DLS SHOOTING RANGE  
RANGE RENOVATION PHASE I  
SCOTT COUNTY, IOWA  
PROJECT NUMBER: 23-06-82-01

July 14, 2023

This Addendum is issued to modify, explain or correct the original Drawings and Specifications, and is hereby made a part of the Contract Documents. Please attach this Addendum to the Project Manual in your possession. Insert the number and issue date of this Addendum in the blank space provided on the Proposal Form.

**01** REFERENCE PLAN - 30 YARD RANGE  
SCALE: 1/4" = 1'-0"

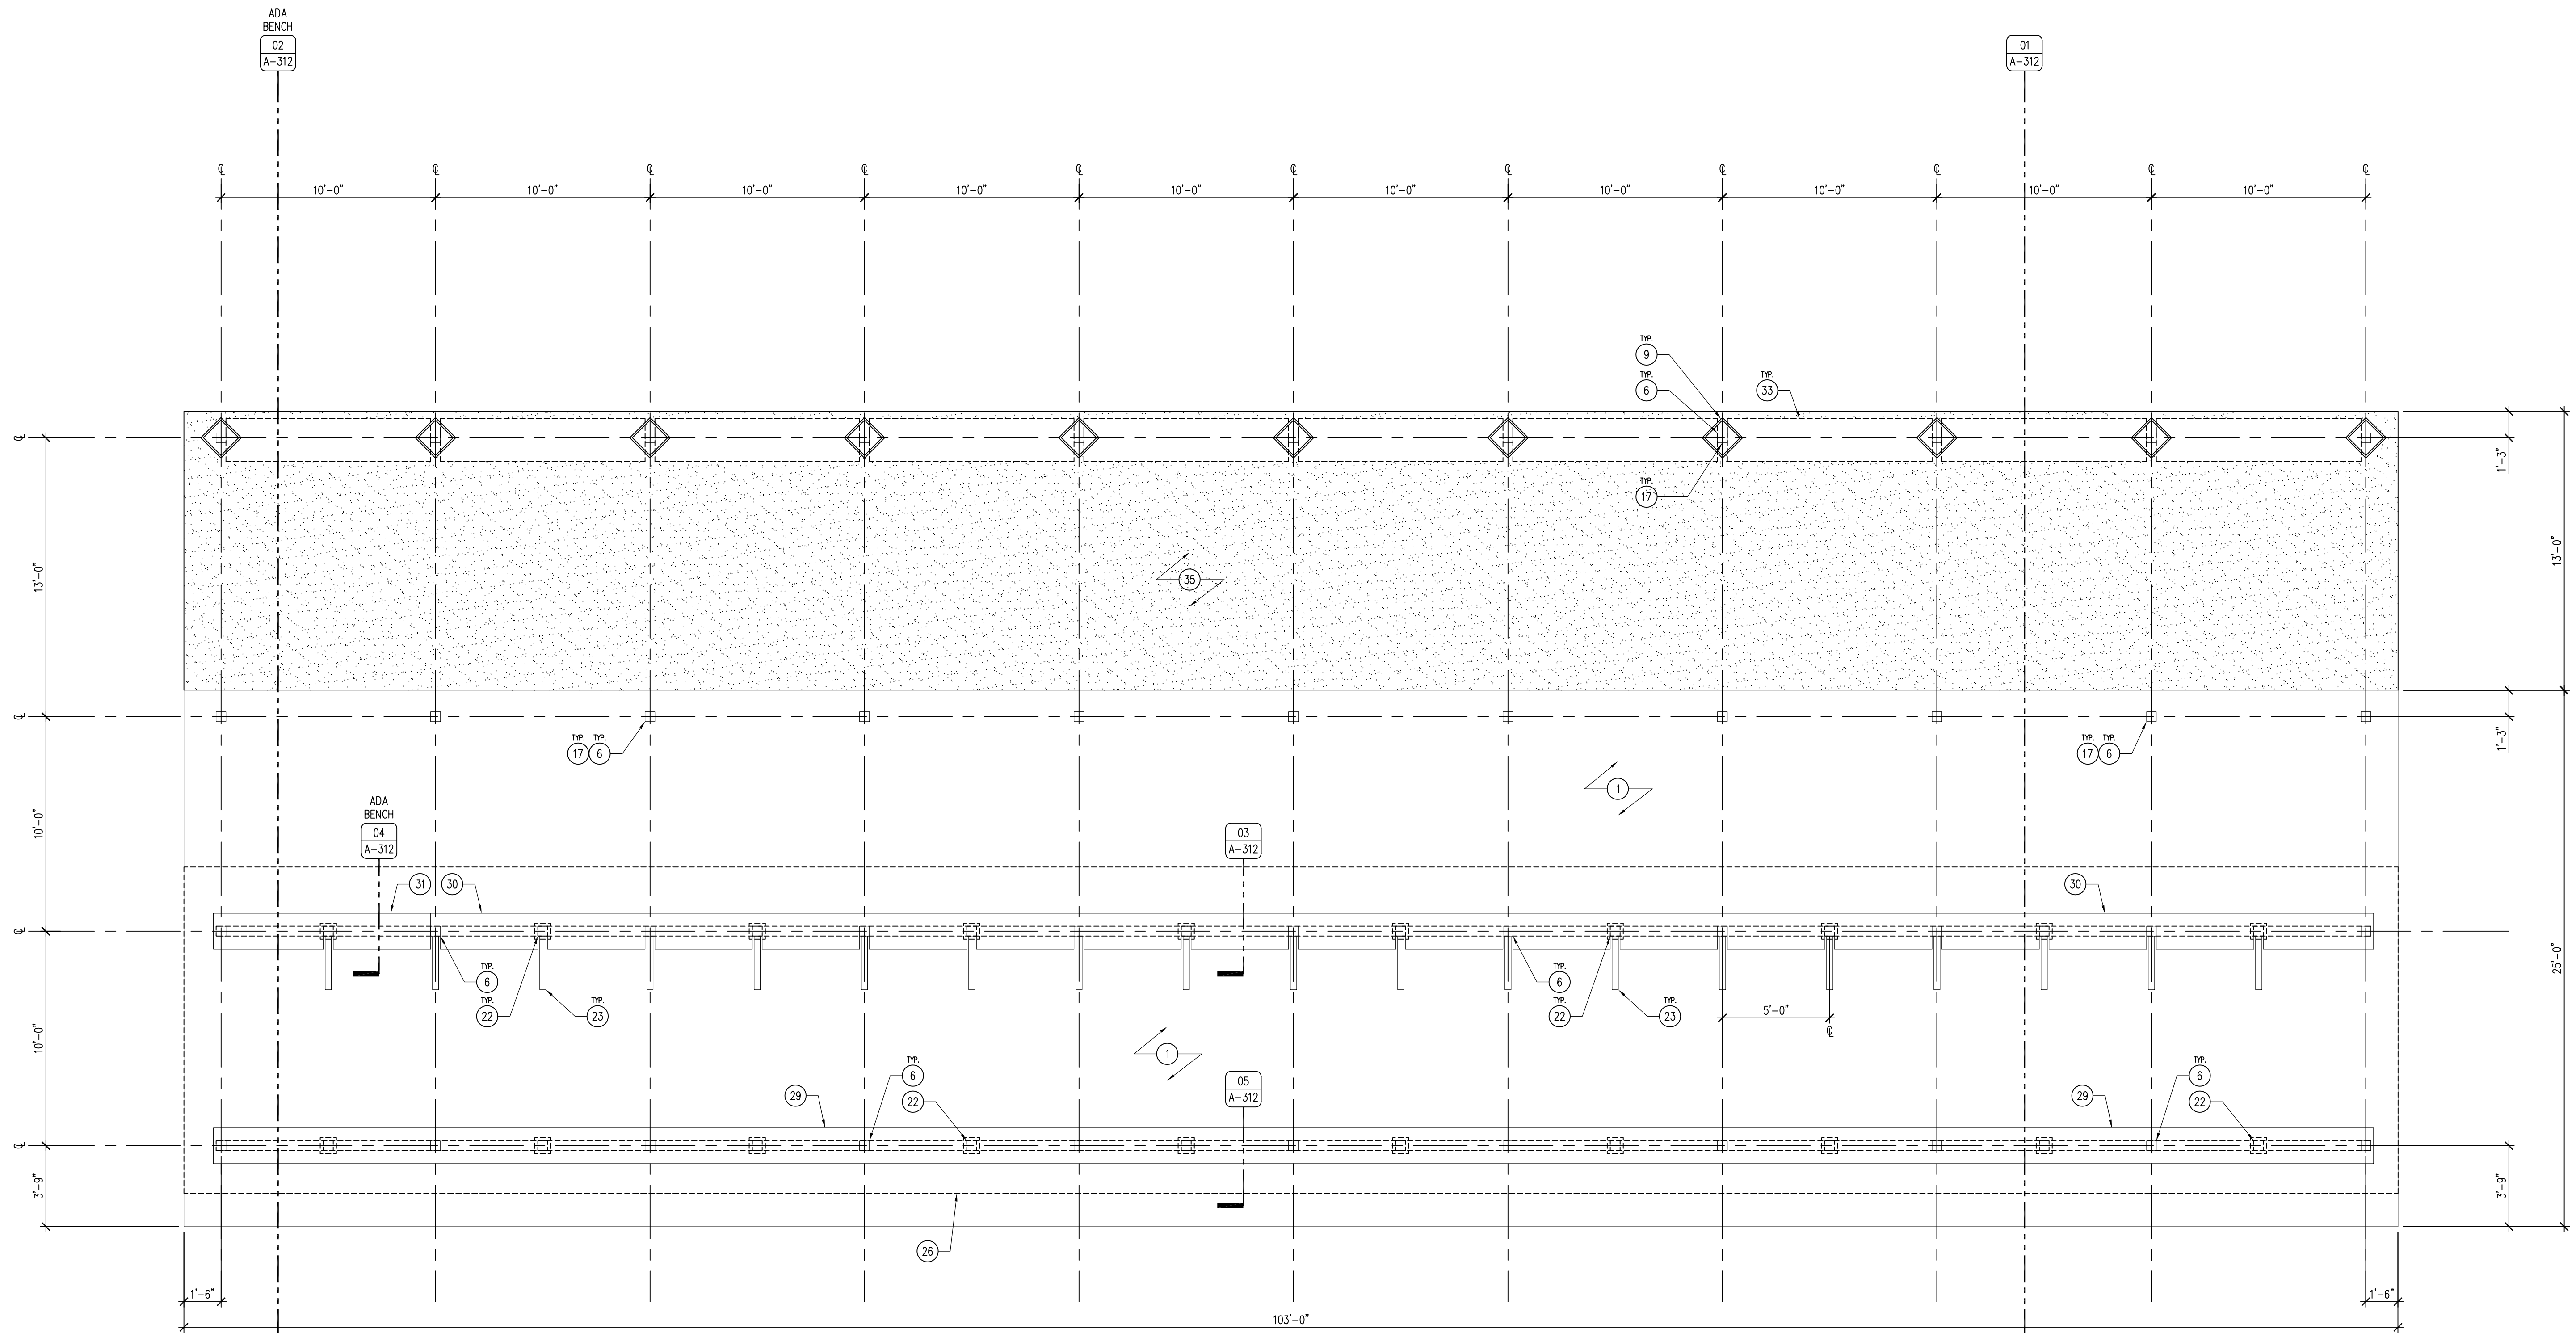
1. Reference Plan 01/A-310 should be 30 yard range (attached superseded drawing)
2. Reference Plan 01/A-311 should be 100 yard range (attached superseded drawing)
3. Detail – Down-Range Steel Shooting Baffle 01/A-314 angles vary, review shooting range sections, plate shall be per keynote #33, 3/8" thick x 10'-0" long x 4'-0" wide (attached superseded drawing)
4. Detail – Sidewall Expansion Joints 04/A-315 should occur every 75 linear feet maximum.

**01** DETAIL – DOWN-RANGE STEEL SHOOTING BAFFLE  
SCALE: 1 1/2" = 1'-0"

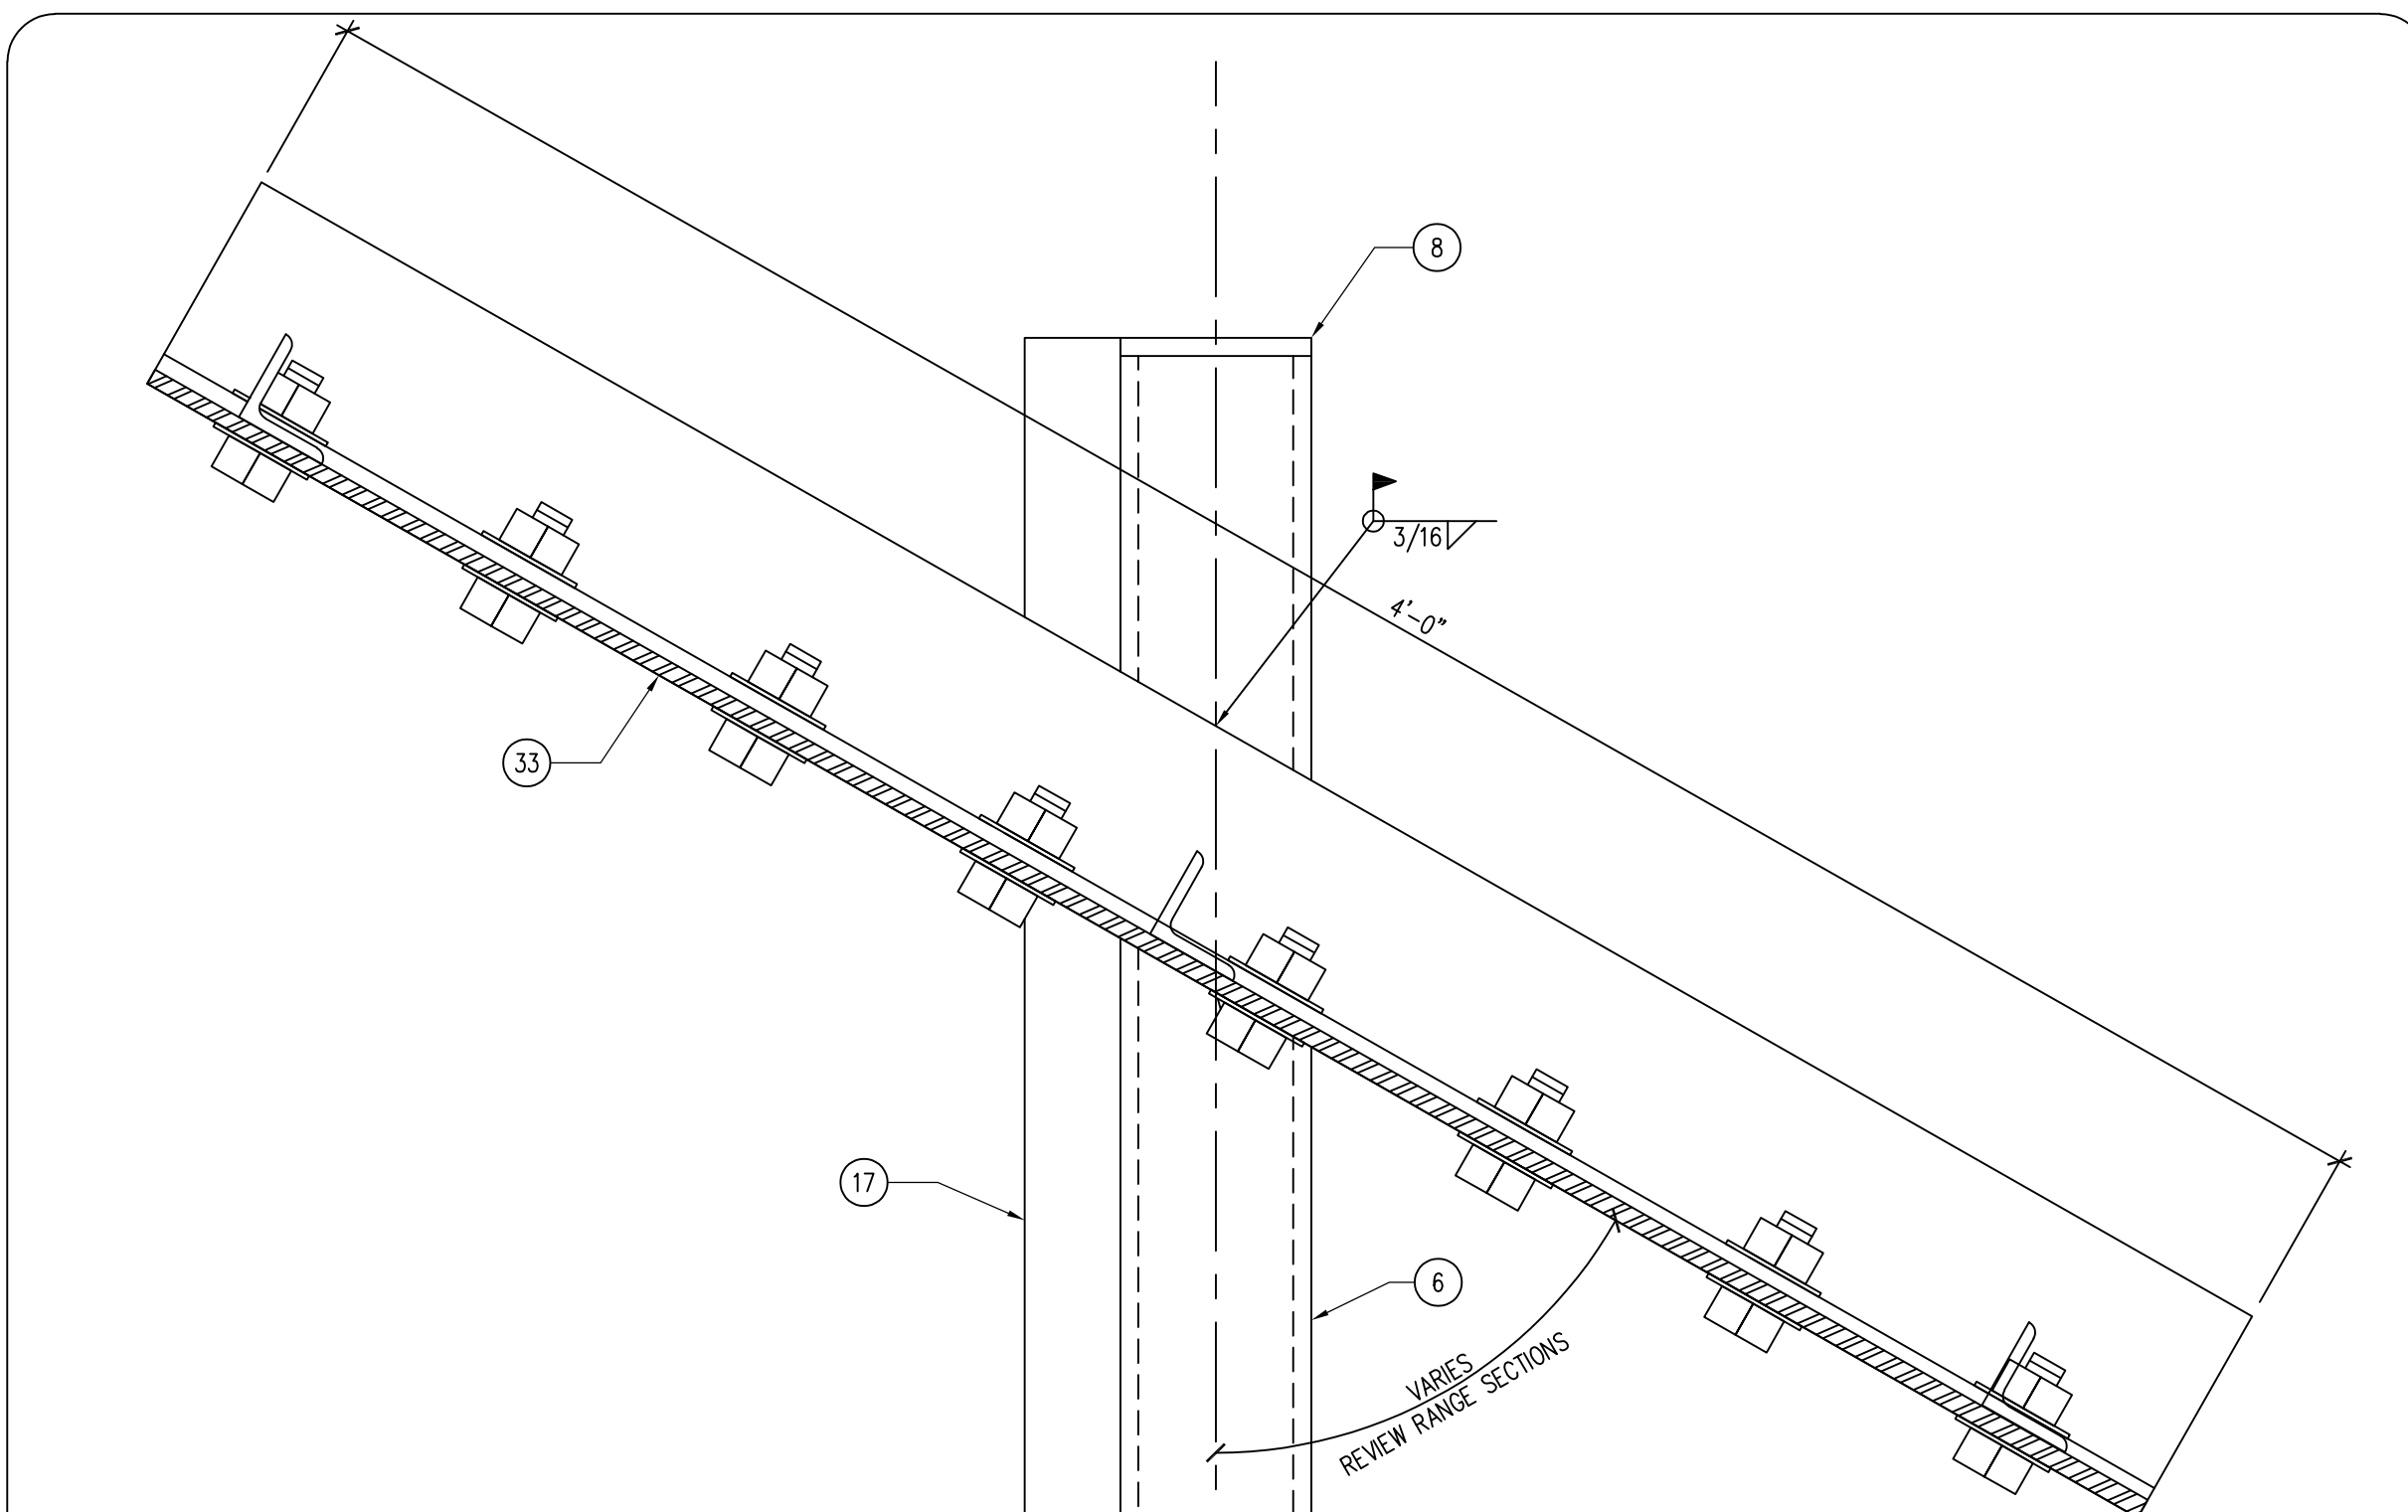
*My question is in line 33 it says the down range plate is 3/8 x 10' x 2'4". However, when looking at the photo it is 4' long But give no other indication on width*

Downrange baffling steel is to be 4'-0" wide as shown on the drawings, note 33 is in error, it should read "33. REMOVABLE ASSEMBLY OF 3/8"X10'-0"X4'-0" AR400 STEEL PLATE BOLTED TO 3/8"X3"X3" ANGLES THAT ARE WELDED TO VERTICAL FACE OF COLUMN, STIFFEN ASSEMBLY WITH STEEL ANGLES AS NECESSARY. ADJUST MOUNTING PLACEMENT WITH DNR STAFF FOR PROPER ANGLES AND HEIGHTS."
